# Access Compliance Report

## Public Rights-of-Way

Intersection ID: N/A	Main Street: WOODLAWN_ST	Cross Street: N/A	Location: S
ADA ID: 815A45DC4394	Ramp Type: Perp	Initial Pass/Fail: Fail	Overall Compliance: No
Severity Score: 12.5			
Codes/Mitigation Info/Possible Solution		Field Measurements/Component Compliance

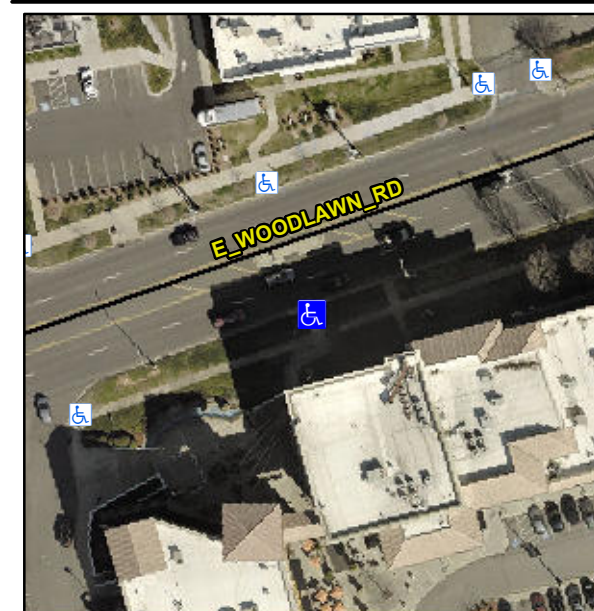
**Not Found, R304.2.2**

Compliance	Description	Data	Compliance	Description	Data
N/A	Ramp Length (in)	145.0	No	Ramp Slope (%)	11.4
Yes	Ramp Width (in)	61.0	Yes	Ramp XSlope (%)	0.8
N/A	Flare Type LT	N/A	N/A	Flare Type RT	N/A
N/A	Flare Slope LT (%)	N/A	N/A	Flare Slope RT (%)	N/A
N/A	Flare Traversable LT?	N/A	N/A	Flare Traversable RT?	N/A
N/A	Landing Length (in)	N/A	N/A	DWS Provided?	N/A
N/A	Landing Width (in)	N/A	N/A	DWS Contrast?	N/A
N/A	Landing Slope (%)	N/A	N/A	DWS Length (in)	N/A
N/A	Landing X Slope (%)	N/A	N/A	DWS Full Width?	N/A
N/A	Landing Curb? (Y/N)	N/A	N/A	DWS Offset (in)	N/A
N/A	Shared Landing?	N/A			
N/A	Gutter Ponding?	N/A	N/A	Gutter Slope (%)	N/A
N/A	Gutter Lip Ht (in)	N/A	N/A	Gutter X Slope (%)	N/A
N/A	Painted X Walk1?	No	N/A	Painted X Walk2?	N/A
	X Walk 1 Direction	To N		X Walk 2 Direction	N/A
N/A	X Walk 1 Width (in)	N/A	N/A	X Walk 2 Width (in)	N/A
	X Walk 1 Slope (%)	7.5		X Walk 2 Slope (%)	N/A
	X Walk 1 X Slope (%)	4.6		X Walk 2 X Slope (%)	N/A

**Remove & Replace Entire Ramp.**
